UNITED STATES
DEPARTMENT OF THE INTERIOR
BUREAU OF LAND MANAGEMENTFORM APPROVED
OMB NO. 1004-0137
Expires: January 31, 2018**SUNDRY NOTICES AND REPORTS ON WELLS**
*Do not use this form for proposals to drill or to re-enter an abandoned well. Use form 3160-3 (APD) for such proposals.*Well Name and No.
LEA SOUTH 25 FEDERAL COM 3BS 7H

LEA SOUTH 25 FEDERAL COM 3BS 7H

PECOS DISTRICT CONDITIONS OF APPROVAL

OPERATOR'S NAME:	Nearburg Operating
LEASE NO.:	NMLC0066126
WELL NAME & NO.:	Lea South 25 Fed Com 2BS 7H
SURFACE HOLE FOOTAGE:	330 'S & 1980'E
BOTTOM HOLE FOOTAGE	330'/N & 2080'E
LOCATION:	Section 25, T.20 S., R.34 E., NMPM
COUNTY:	Lea County, New Mexico

System Drawing

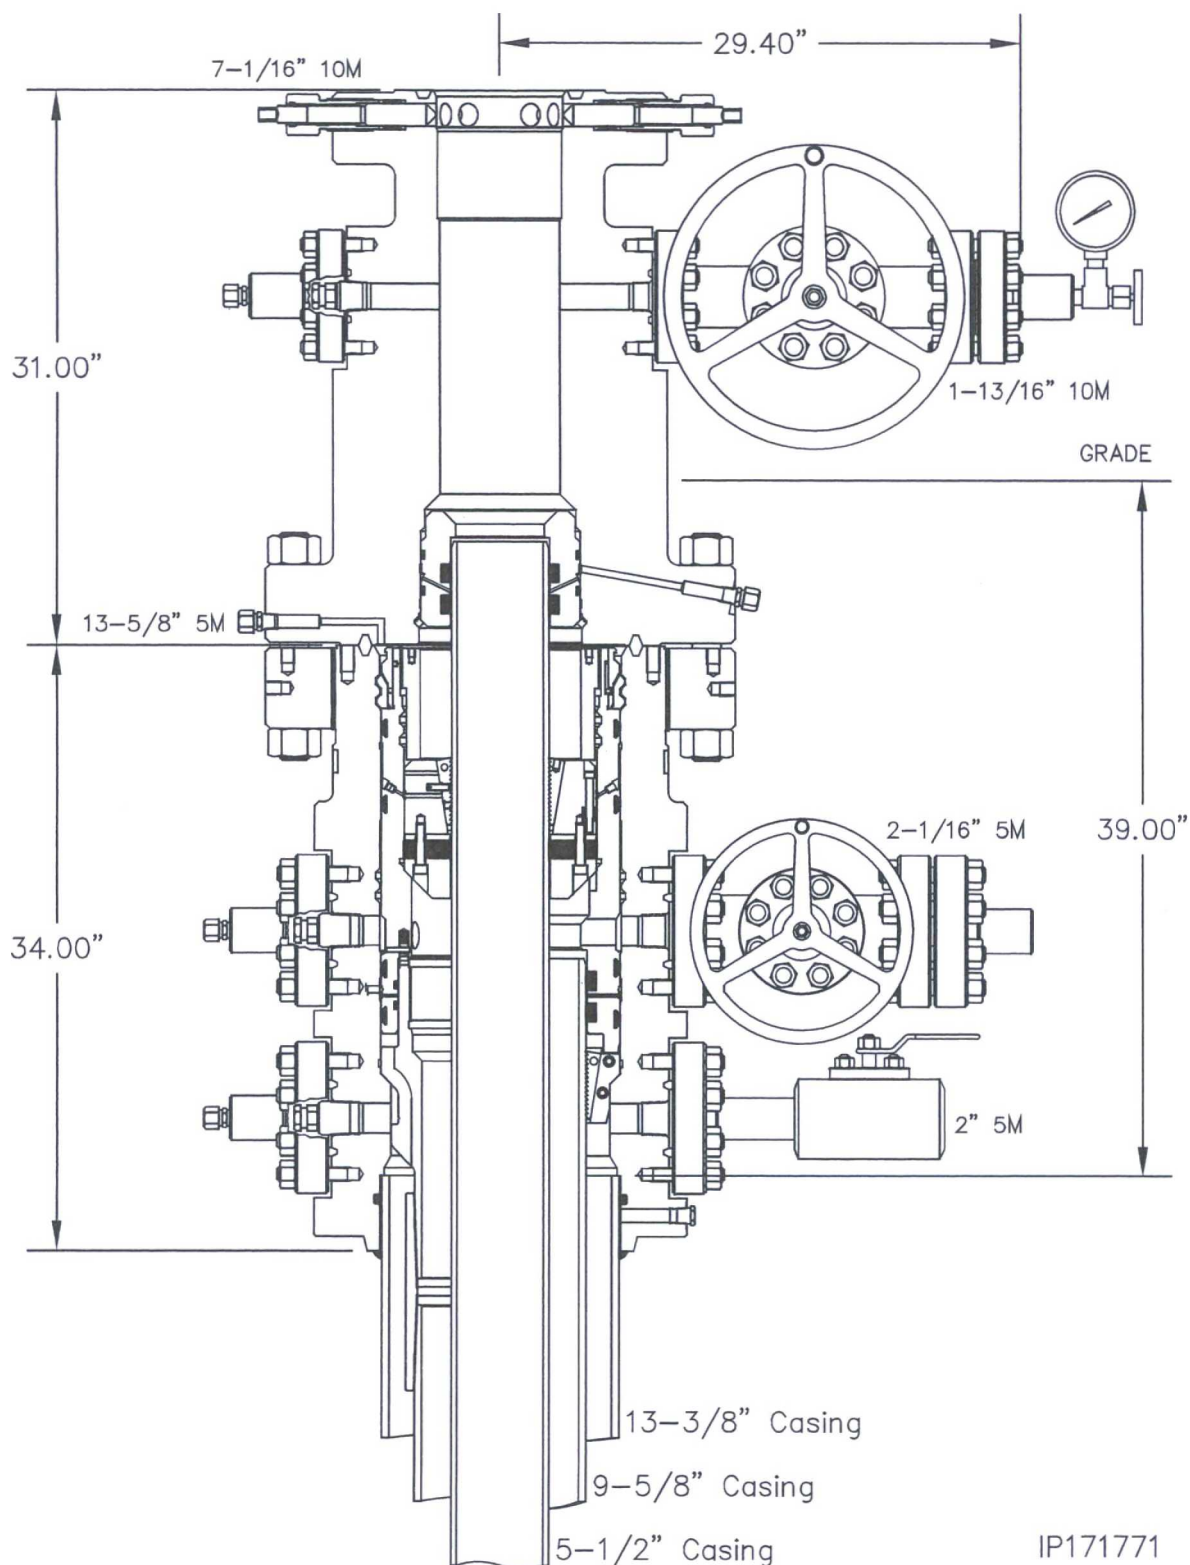
B. (1)-We will be utilizing a Cactus Speedhead for this well. Please see attached diagram for speed head.

- 1. Operator has proposed a multi-bowl wellhead assembly. This assembly will only be tested when installed on the surface casing. Minimum working pressure of the blowout preventer (BOP) and related equipment (BOPE) required for drilling below the surface casing shoe shall be 5000 (5M) psi.**

- a. Wellhead shall be installed by manufacturer's representatives, submit documentation with subsequent sundry.**
 - b. If the welding is performed by a third party, the manufacturer's representative shall monitor the temperature to verify that it does not exceed the maximum temperature of the seal.**

- c. Manufacturer representative shall install the test plug for the initial BOP test.**
 - d. Operator shall perform the intermediate casing integrity test to 70% of the casing burst. This will test the multi-bowl seals.**

- e. If the cement does not circulate and one inch operations would have been possible with a standard wellhead, the well head shall be cut off, cementing operations performed and another wellhead installed.**
